August 29, 2024

Re: Comments on Texas GulfLink, LLC, National Environmental Policy Act Final Environmental Impact Statement, Docket No. MARAD-2019-0093

Figure 2. Texas GulfLink Offshore Oil Spill Risk

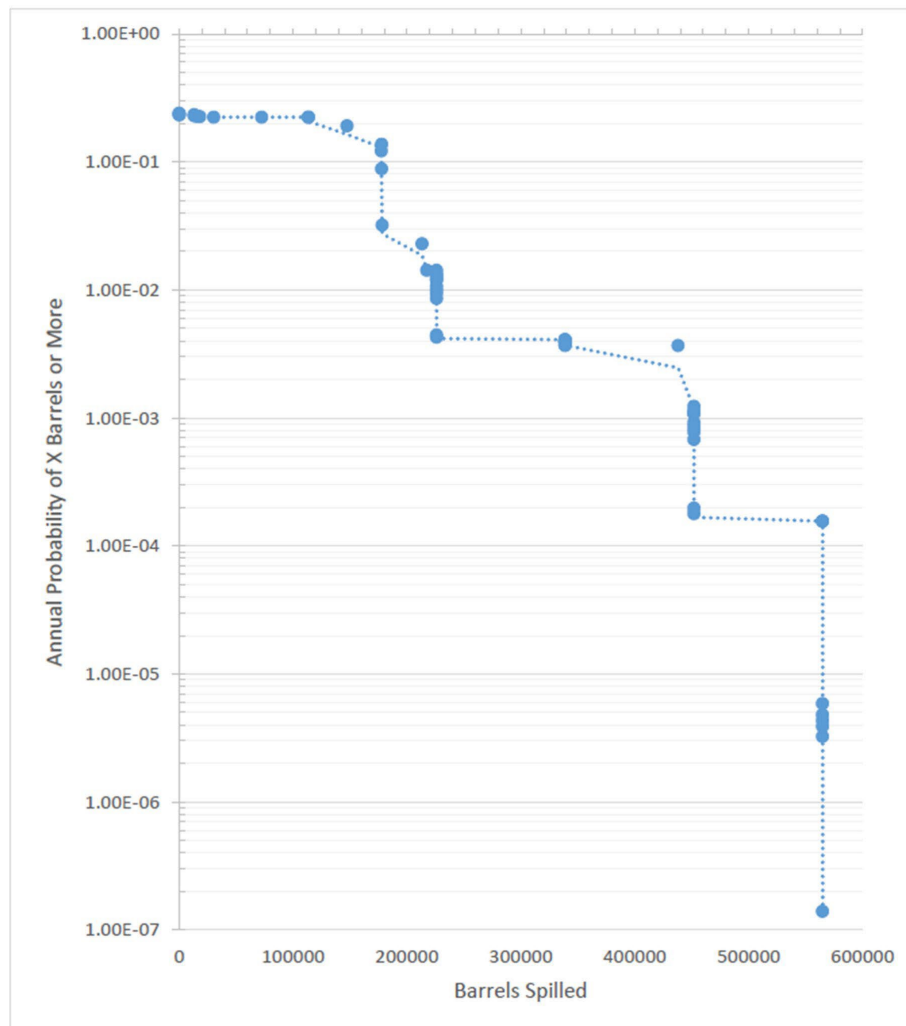
In their responses to our comments on the SDEIS, MARAD and USCG defend the Risknology report and their analysis of oil spill risk by claiming that 1) our comments misread the GulfLink oil spill risk figure in the FEIS (Figure 4.6.1-1) because the figure's y-axis shows frequencies rather than probabilities of oil spills (i.e., the agency's own figure is mislabeled), 2) the FEIS clarifies how to interpret the exceedance curve in Figure 4.6.1-1 to be more discernable to the public, 3) the FEIS's cumulative impact analysis of oil spills is adequate, and 4) an analysis of varying ranges of oil spill sizes and frequencies would be "duplicative" of the analysis of the worst credible discharge scenario presented in the Risknology report.¹¹⁸ None of these responses cures the flaws of the oil spill risk analysis.

First, it is unclear how MARAD and USCG reached the conclusion that the y-axis of Figure 4.6.1-1 in the FEIS depicts frequencies when the figure's y-axis itself

states that it is depicting the “[a]nnual [p]robability of X [b]arrels or [m]ore” of oil spilled (see figure reproduced below).¹¹⁹

In any case, if the y-axis of this figure depicts annual frequency of oil spills instead of annual probability, then this figure confirms that the likelihood of large oil spills (each year and over the 30-year lifetime of the Project) is very significant.¹²⁰ Dr. Susan C. Lubetkin, an expert in environmental risk statistics and analysis, has assumed that the figure depicts frequencies per year (as MARAD

Second, in our comments on the SDEIS, we noted that MARAD and USCG must provide more information to the public regarding how to interpret Figure 4.6.1-1 above.¹²⁷ NEPA requires agencies to present information in an accurate and clear manner in order to facilitate informed public participation. As mentioned, here, the agencies acknowledge that the figure itself is mislabeled.¹²⁸ Additionally, in the FEIS, MARAD and USCG attempt to "clarify" how to interpret Figure 4.6.1-1 by stating that "Figure 4.6.1-1 is presented on a logarithmic scale (NRC 1996)" and that "[a]dditional information regarding how to read exceedance curves can be found on the National Weather Service Climate Prediction Center Website (NOAA 2002)."¹²⁹ This addition, however, does nothing to help the public understand how to interpret the exceedance curve depicted in Figure 4.6.1-1. For example, the NOAA webpage cited provides no graphs of exceedance curves that would help the average reader identify exceedance curves or understand what Figure 4.6.1-1 depicts.¹³⁰
